Product Change Notification

Change Notification #: 107064 - 00

Change Title: Intel® PRO/Wireless 2200BG Network Connection Skus: WM3B2200BGMWF, RWF, MWXF, RWXF, RW2F, (MM# 867074, 867073, 867055, 867053, 867111), PCN 107064-00, Label, Update Singapore Regulatory Marking, update Mexico Certification #, and add Regulatory Markings for India, Argentina, Pakistan, Peru and Uruguay

Date of Publication: December 06, 2006

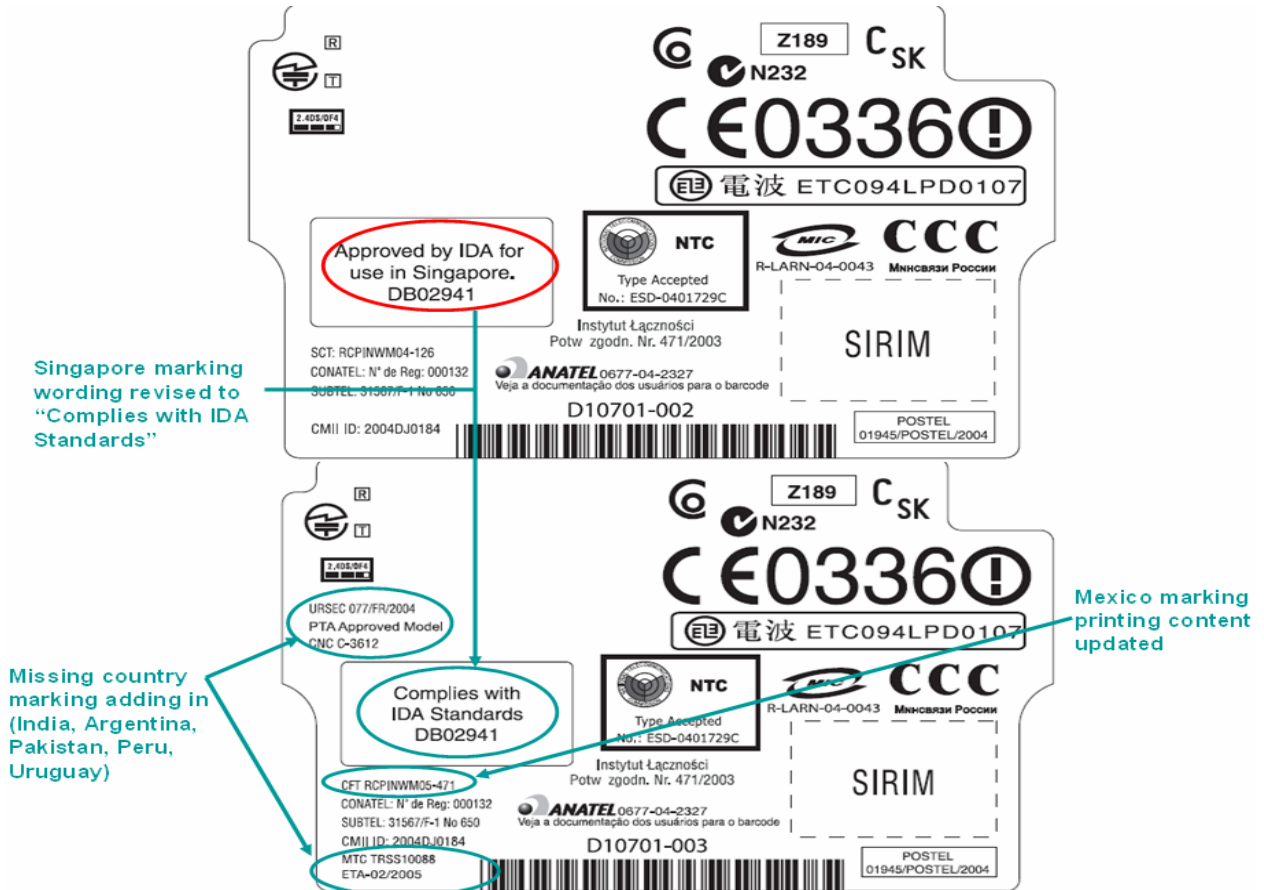
This ECO cycle implements multiple changes as per Cadence ECO process:

1. Singapore IDA marking change to comply with Singapore regulatory requirement
2. Update certificate number for Mexico country marking (renewal of certificate)
 - a. From SCT: RCPINWM04-126 change to CFT RCPINWM05-471
3. Add in country logo markings for India, Argentina, Pakistan, Peru and Uruguay

1. Singapore IDA marking wording change.
2. Country marking adding in (India, Argentina, Pakistan, Peru and Uruguay), and
3. Update to certificate number for Mexico country marking.

- From SCT: RCPINWM04-126 change to CFT RCPINWM05-471
